**Comanche Peak Nuclear Power Plant, Units 3 & 4
COL Application**

**Part 2, FSAR
Update Tracking Report**

**Revision 7
(Non-Security Related Version)**

Figure 2.4.1-213 CPNPP Site and Site Vicinity Water Wells

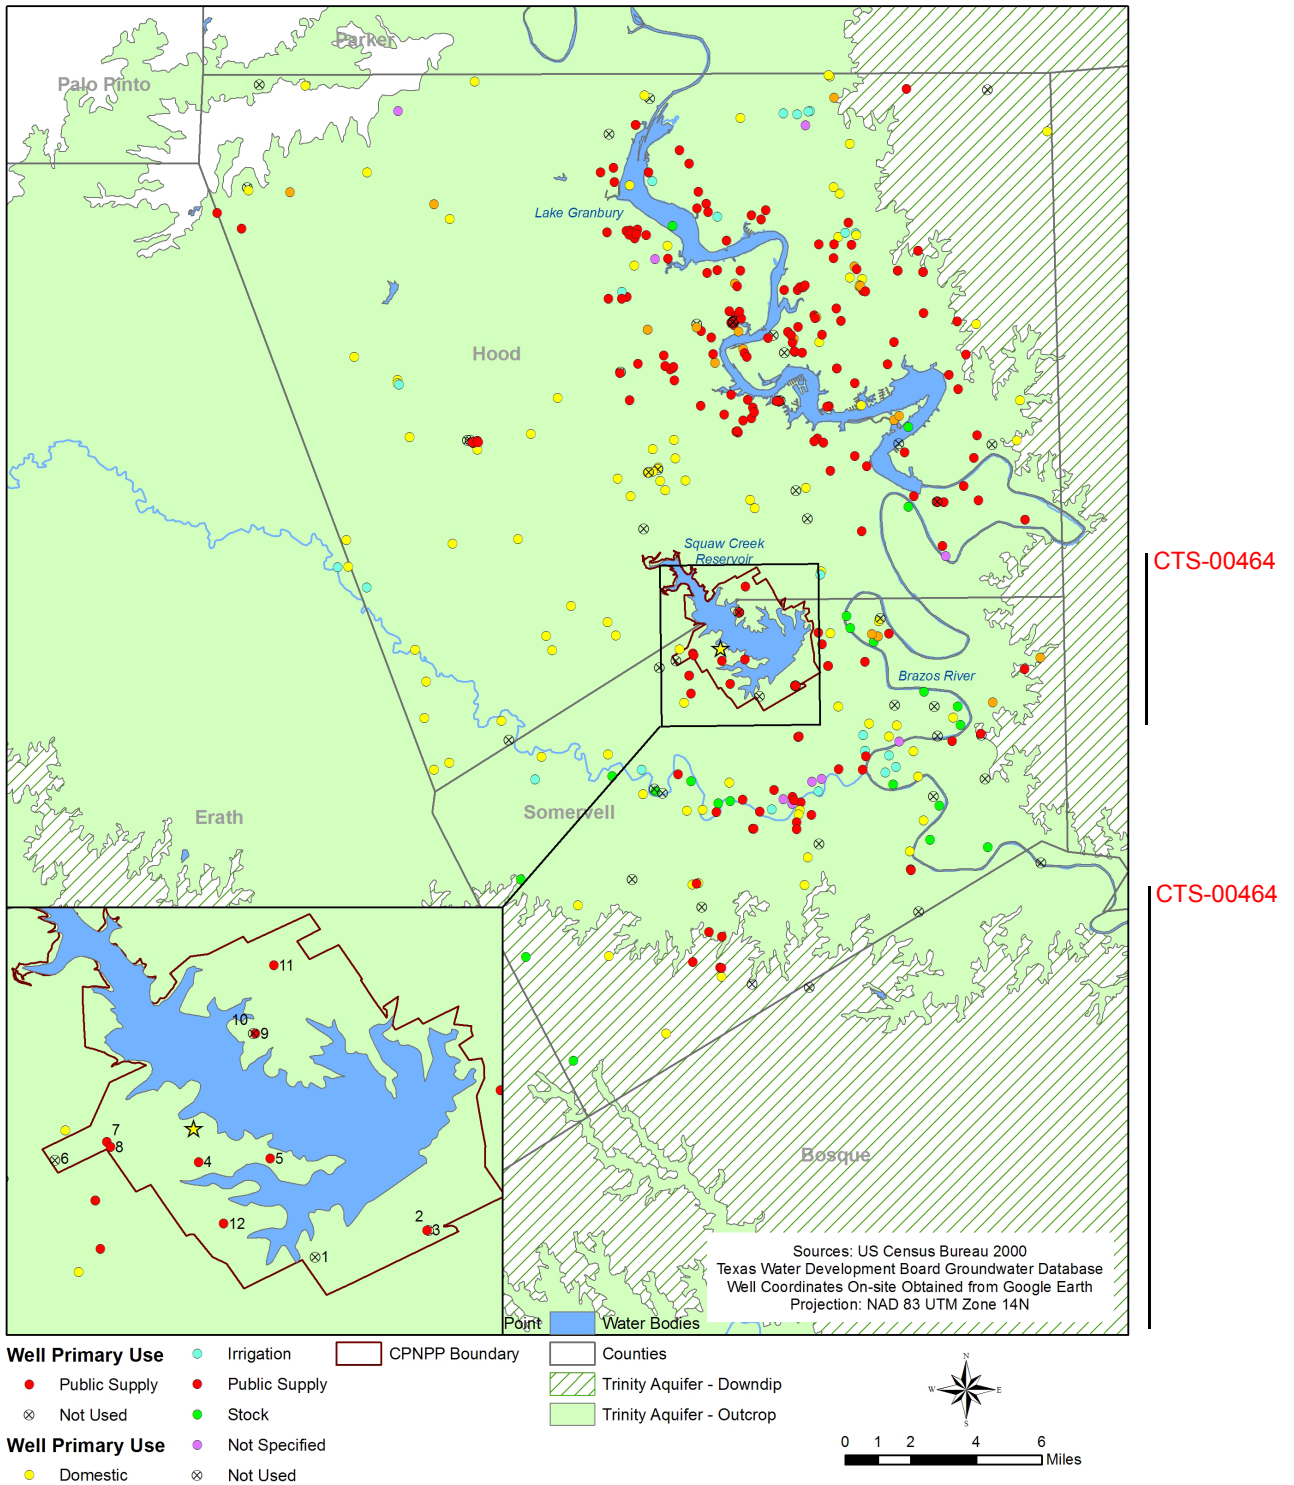
CTS-00464	Figure 2.4.1-213	-	Erratum	Updated Figure to show correct well locations.	7
MAP-2.3-001	Table 2.3-338	2.3-240	DCD change	The distances are	7

Figure 8.2-203 Normal PPS Unit Switchyard One Line Diagram

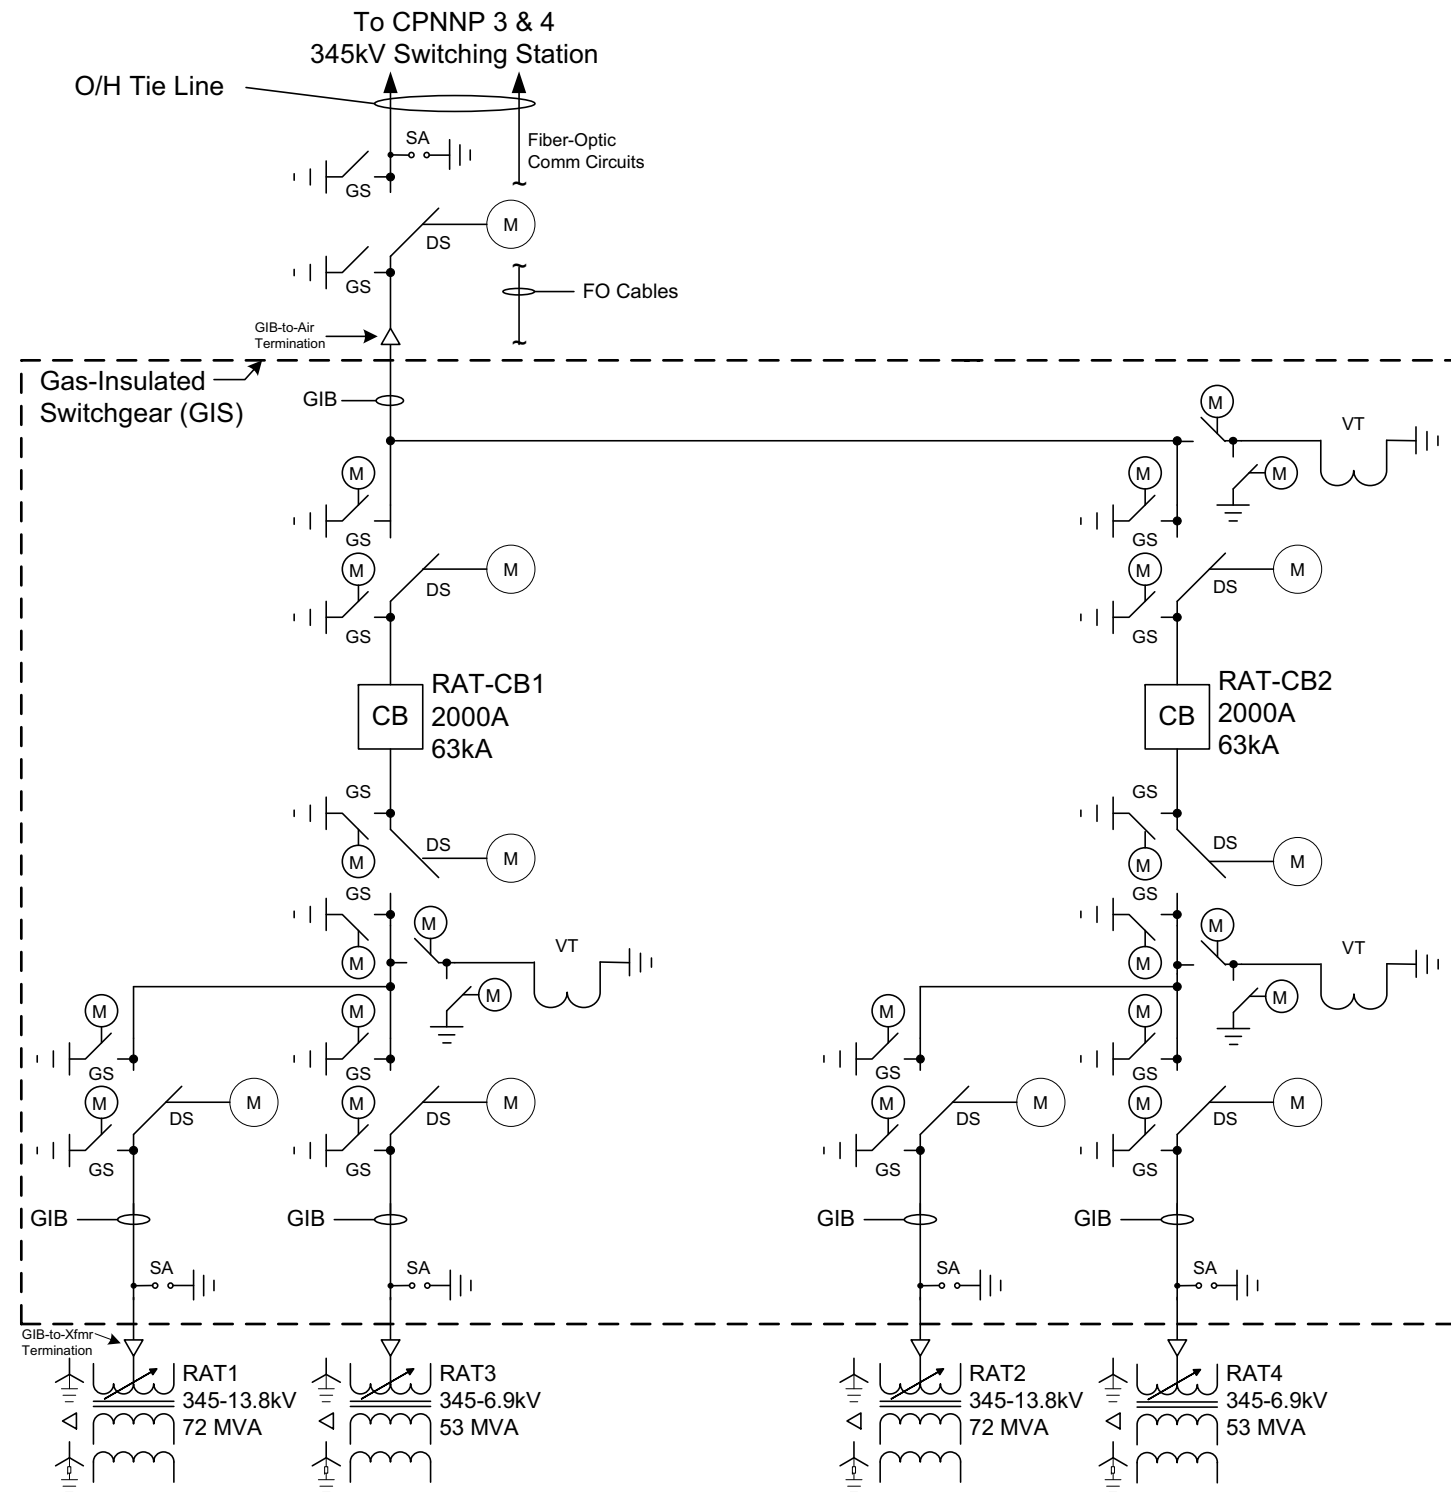
Change ID No.	Section	FSAR Rev. 0 Page	Reason for change	Change Summary	Rev. of FSAR T/R
MAP-08-101	Figure 8.2-203	8.2-25	Change capacity of UAT and RAT	Change RAT1 and RAT2 capacities from "65MVA" to "72MVA".	7
MAP-08-101	Figure 8.2-204	8.2-26	Change capacity of UAT and RAT	Change UAT1 and UAT2 capacities from "65MVA" to "72MVA".	7
MAP-08-104	8.3.1.1.9	8.3-1	Add subsections 8.3.1.3 and 8.3.2.3 in DCD	Changed reference section from "8.3.1.3" to "8.3.1.3.2" in the second paragraph.	7
CTS-00908	8.3.1.1.11	8.3-1	Editorial correction	Replaced "STD COL 8.3(2)" with "CP COL 8.3(2)"	7
MAP-08-104	8.3.1.3.2	8.3-2	Add subsections 8.3.1.3 and 8.3.2.3 in DCD	Replaced all of paragraphs for STD COL 8.3(3) and added subsection 8.3.1.3.2.	7
DCD_08.03.01-32	8.3.1.3.4	8.3-2	Reflect Response to DCD RAI No. 386	Added subsection 8.3.1.3.4.	7
DCD_08.03.01-33	8.3.1.3.5	8.3-2	Reflect Response to DCD RAI No. 386	Added subsection 8.3.1.3.5.	7

**Figure 8.3.1-1R Onsite AC Electrical Distribution System (Sheet 5 of 7)
Class 1E 480V Buses A and B One Line Diagram**

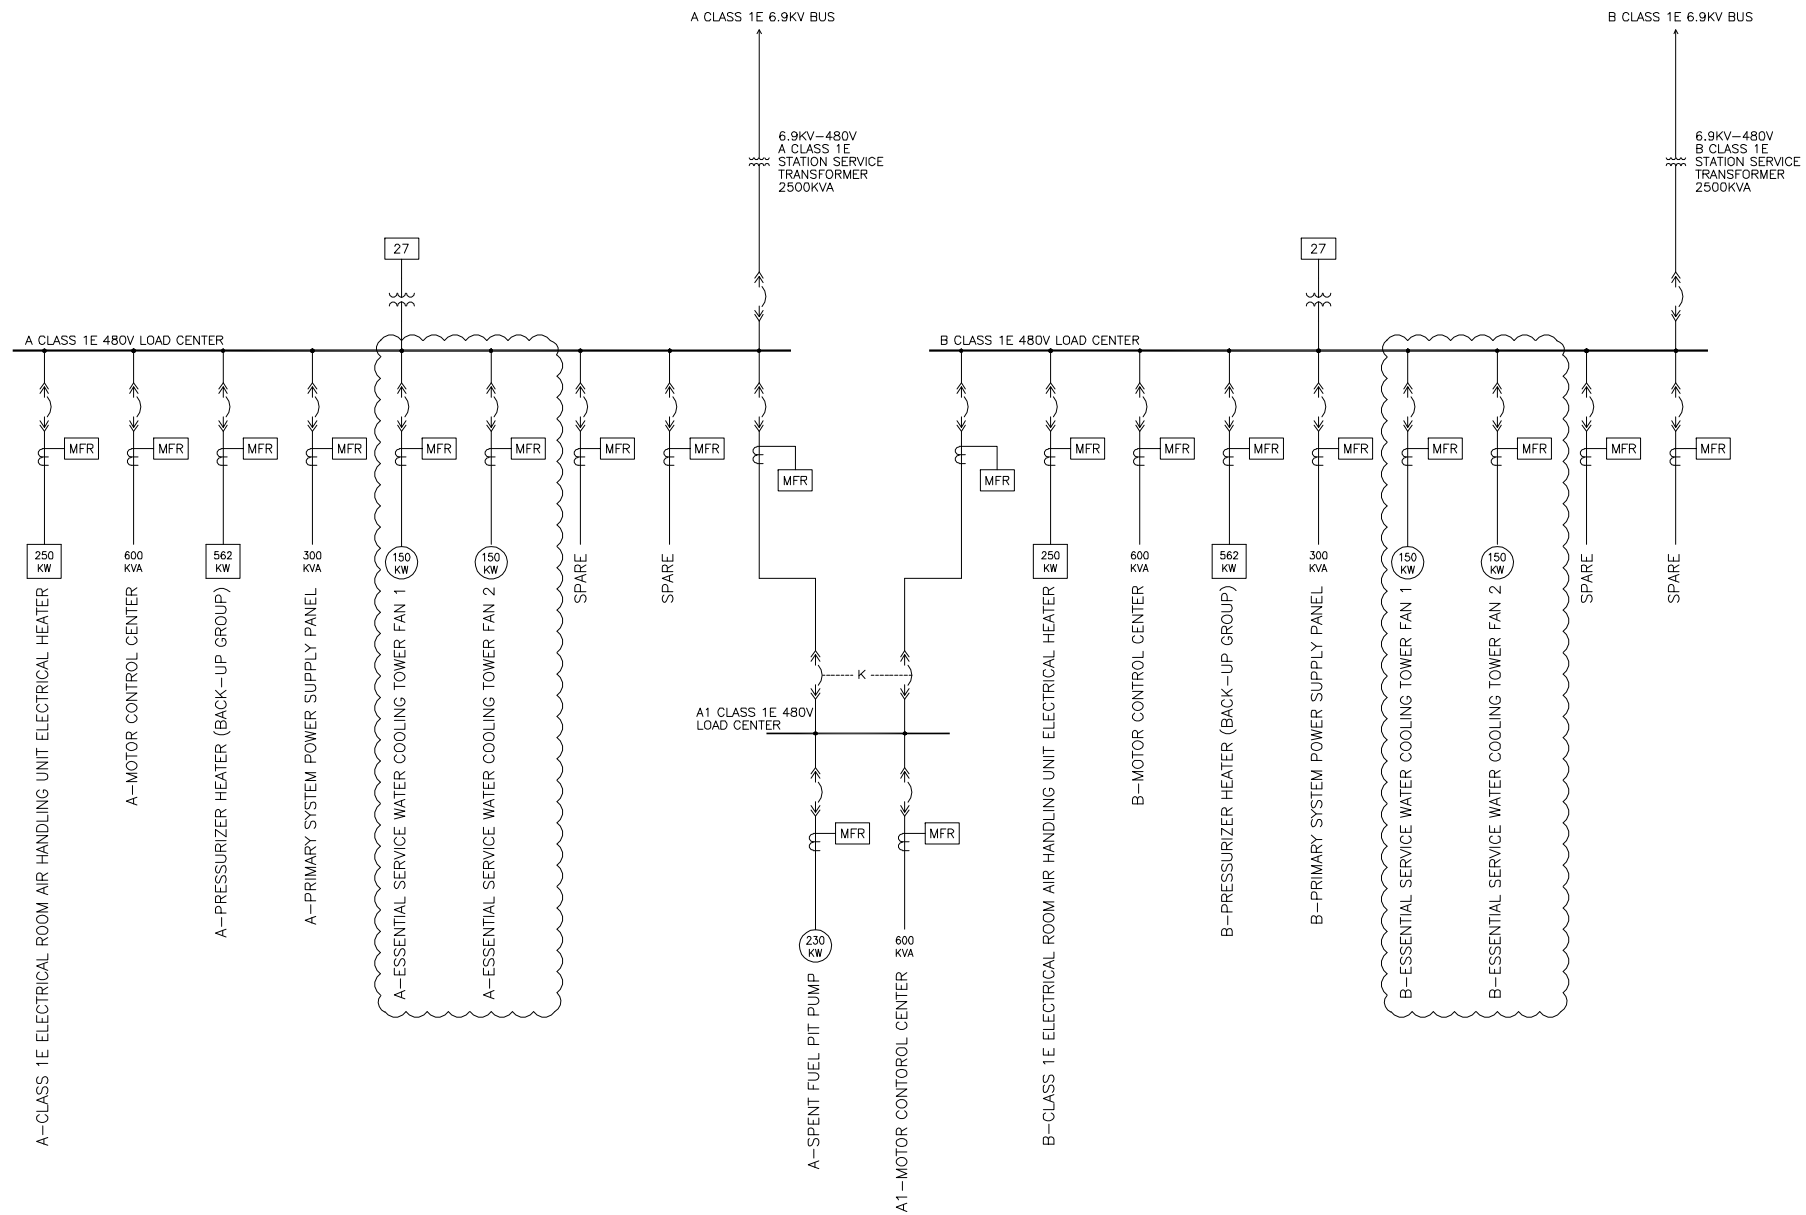
MAP-08-102	Figure 8.3.1-1R (Sheet 5 of 7)	8.3-11	Change threshold of motor capacity connected MV bus of LV bus	Changed from "A-ESSENTIAL CHILLERUNIT" to "SPARE". And changed from "B-ESSENTIAL CHILLERUNIT" to "SPARE".	7
MAP-08-102	Figure 8.3.1-1R (Sheet 6 of 7)	8.3-12	Change threshold of motor capacity connected MV bus of LV bus	Changed from "C-ESSENTIAL CHILLERUNIT" to "SPARE". And changed from "D-ESSENTIAL CHILLERUNIT" to "SPARE".	7

**Figure 8.3.1-2R Logic Diagrams (Sheet 3 of 24)
Non-Class 1E 13.8kV Incoming Circuit Breaker Tripping and Closing**

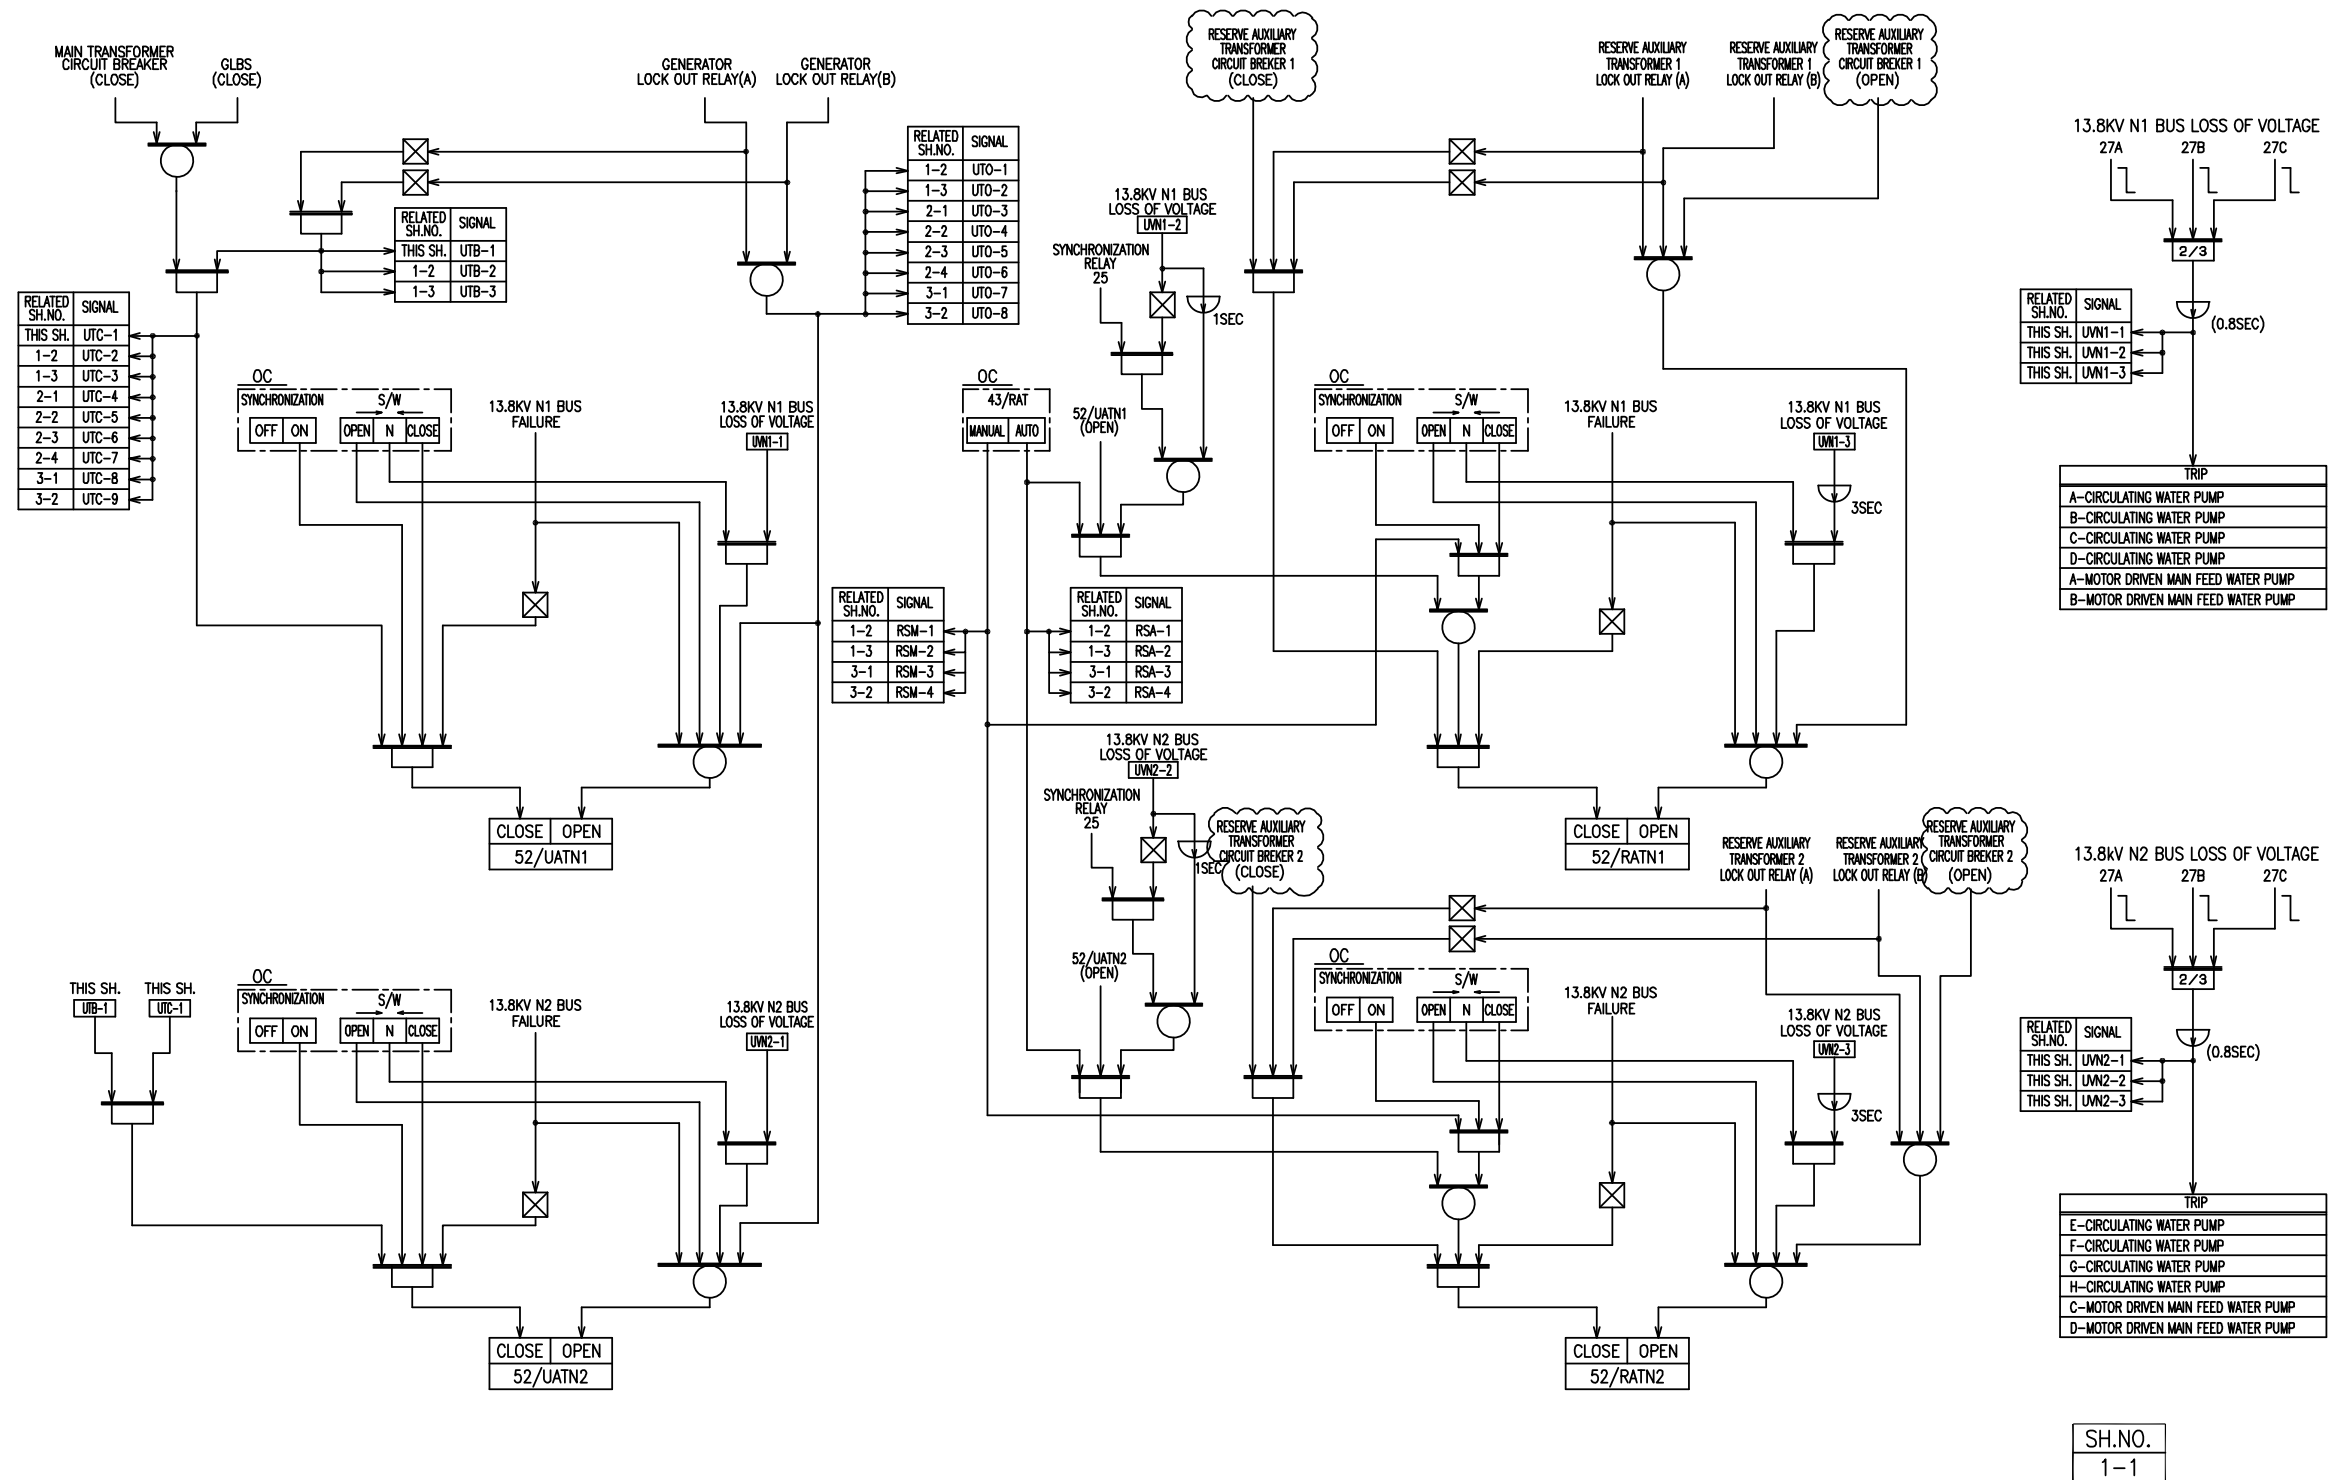
Change ID No.	Section	FSAR Rev. 0 Page	Reason for change	Change Summary	Rev. of FSAR T/R
DCD_08.03.01-23	Figure 8.3.1-2R (Sheet 3 of 24)	8.3-14	Reflect Response to DCD RAI No. 386	Added signal outputs from RAT OC control (MANUAL and AUTO) to sheet "3-1" and "3-2", respectively.	7
